Application Number SSD-77608714-Mod-2

Modification Increase building height and other external modifications

Location 1 Darling Point Road, Edgecliff (formerly 136-148 New South Head Road)

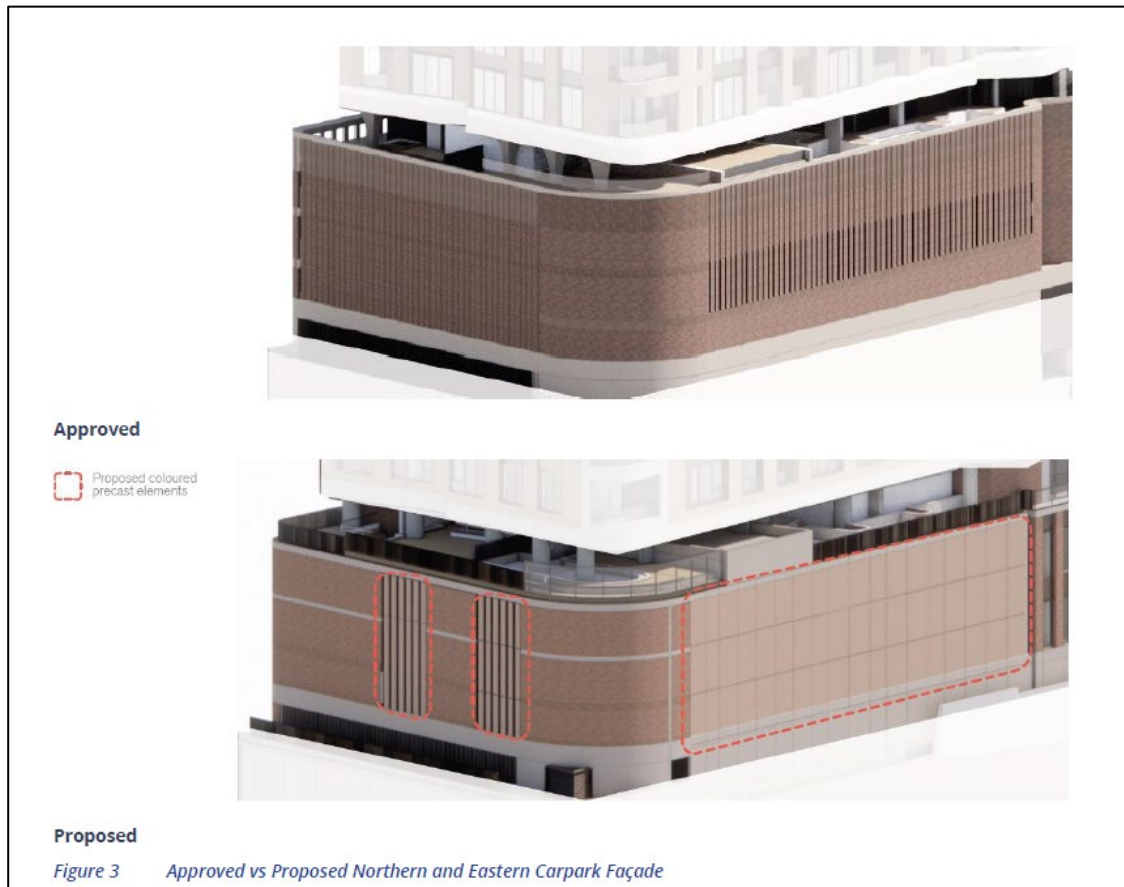
The proposal seeks to change the form and frequency of the brick louvered façade treatment. The approved design offers more frequent and finer louvred blades. The modification seeks a thicker, less frequently spaced, concertina form as depicted in the images below from the modification report.

The sense of bulk of the façade, particularly at the podium level where it makes the strongest impression on the streetscape, will be increased significantly, and particularly from views to the site from Edgecliff Station. The modification will now present as a solid wall, rather than what was effectively a "reeded finish". The modification will no longer have the same degree of undulation, movement and texture that the louvred design had, which would have helped to "soften" the interface with the heritage item on the corner.

The approved façade to the carpark, with denser brick piers, a finer texture, and a higher brick parapet, is a more cohesive and refined design.

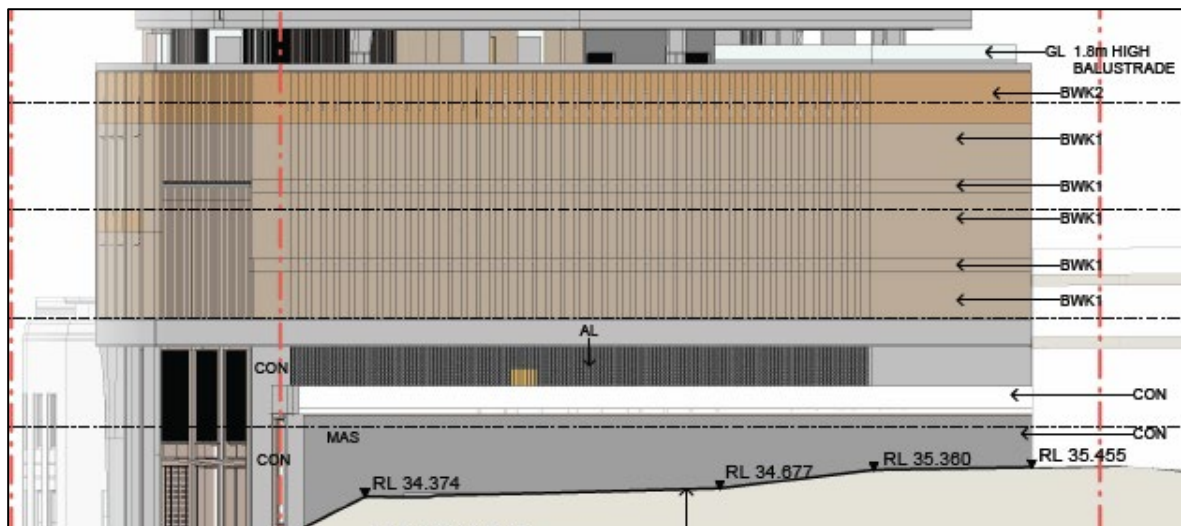
- North elevation – The carpark façade is changed from articulated slivered brick to coloured pre-cast concrete panels, and the base is amended from masonry to precast concrete.

The materiality of the podium level façade treatments has changed to substantially more concrete over brickwork. This is particularly evident on the north elevation, where brick has been replaced for precast concrete, and precast concrete replaced by mass concrete. This further reduces the texture, warmth and definition on the façade and the characteristics that made it more sensitive to the heritage item.

Generally, across the board, changes in material from brick to concrete, or brick to aluminium, is a reduction in the warmth and texture that was originally proposed. The original proposal is more sensitive to the character of the heritage item.

East Elevation Approved

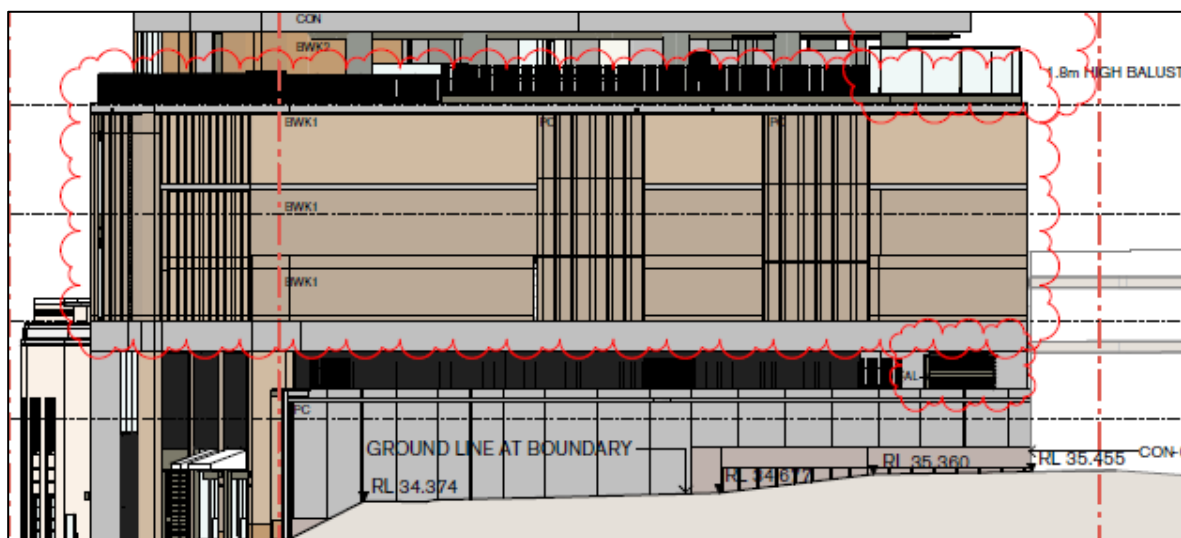
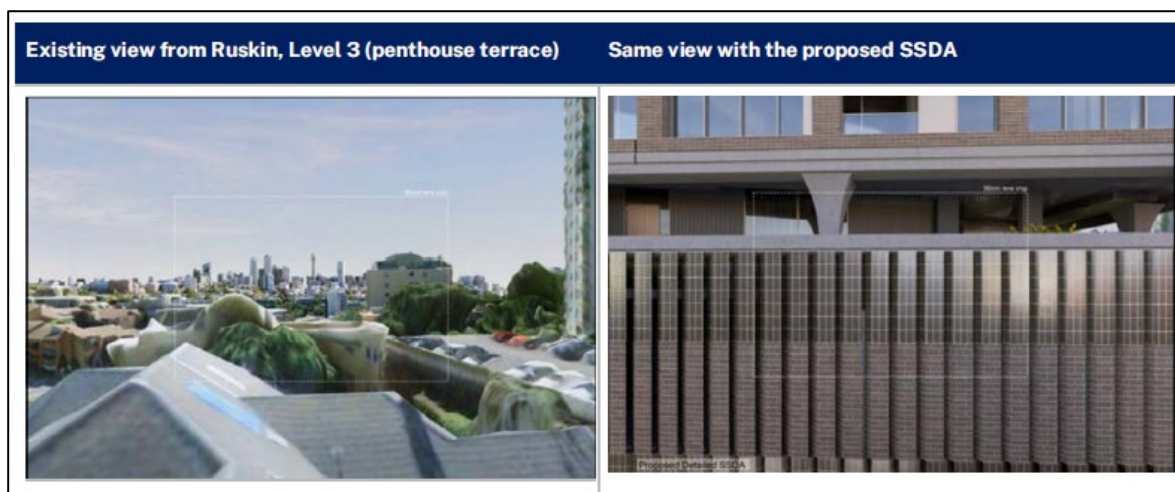
The approved scheme adopted a bladed brick expression to both the eastern and northern frontages of the above ground car park to mitigate the visual impact to the neighbouring properties.

The change in materials and reduction in articulation, results in a poorer outcome when viewed from the neighbouring properties. The approved articulation and design detail is important as the outlook from several properties to the east and north (which include views to the city skyline and district views) will be replaced entirely with views of the podium. Refer to the image below from the Visual Impact Assessment submitted with the original SSD application.

The reduction to the articulation and the quality of the materials should not be supported.

Approved unfinished and polished brick design

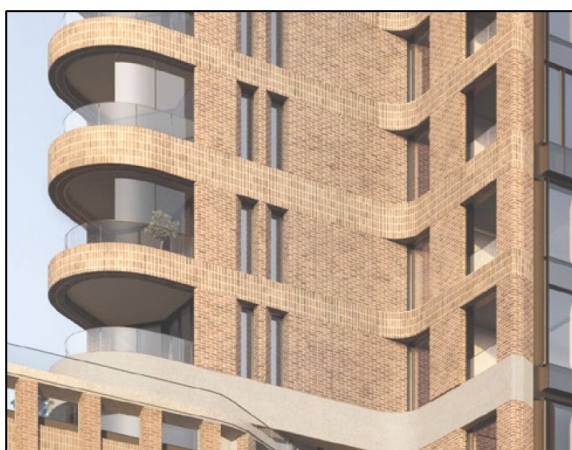
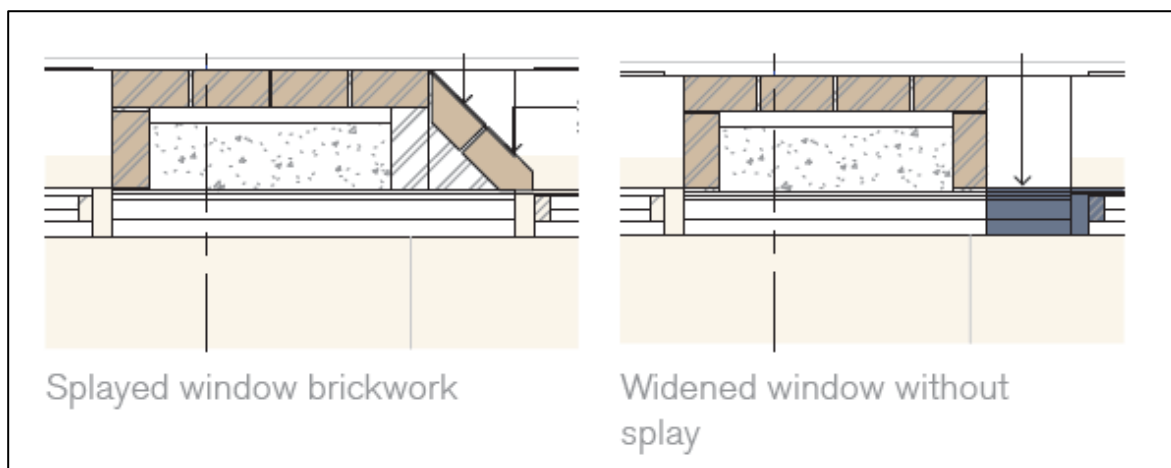
The modification application replaces the approved polished brick with an alternate standard brick.

The removal of the polished brick removes the visual interest to the facade.

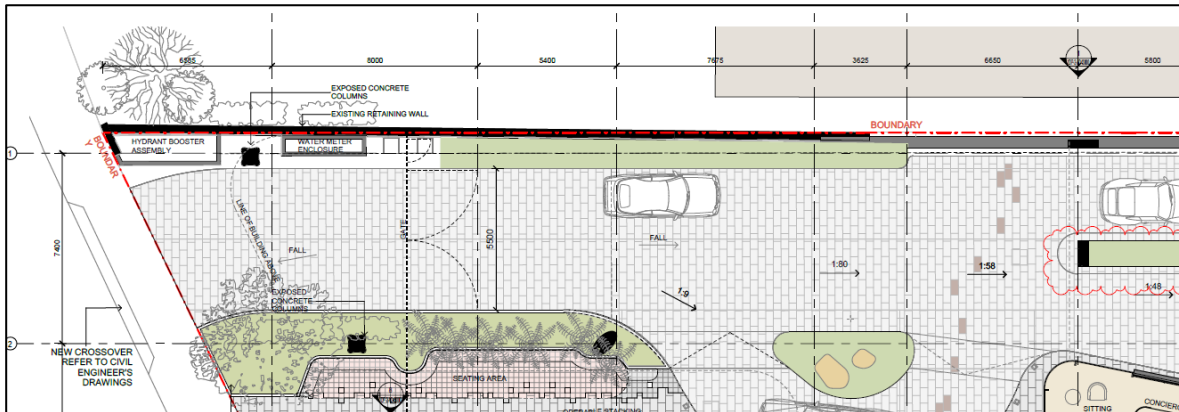
The approved planter, extended for approximately 5m across the southern pedestrian walkway. The proposed glass screen extends approximately 1.5m. The modification application was not accompanied by an updated wind statement confirming the proposed glass screen is adequate in terms of wind mitigation.

Condition A.5 c) of the development consent states that no approval is granted for works on land identified for land acquisition. Both a portion of the landscape planter and the proposed glass screen are located on land identified for land acquisition.

The hatched land acquisition area is incorrectly depicted on the proposed ground floor plan (i.e. the hatching is omitted from the location of the glass screen) but is correctly denoted on all other floor plans.

The proposed amendment is not supported for the following reasons:

Approved ground floor plan

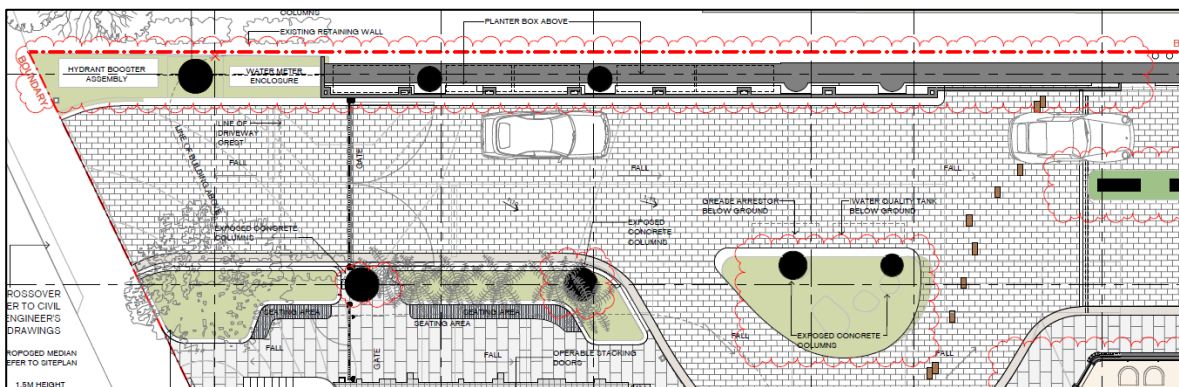
The submitted documentation is unclear in relation to whether the existing retaining wall to the northern boundary is to be retained. The proposed demolition plan details the retention of the wall, but whilst denoted, the retaining wall is no longer clearly depicted on the ground floor plan (refer to approved and proposed ground floor plan extracts below).

The retaining wall to the northern boundary has heritage significance. It should be confirmed that the retaining wall is to be retained.
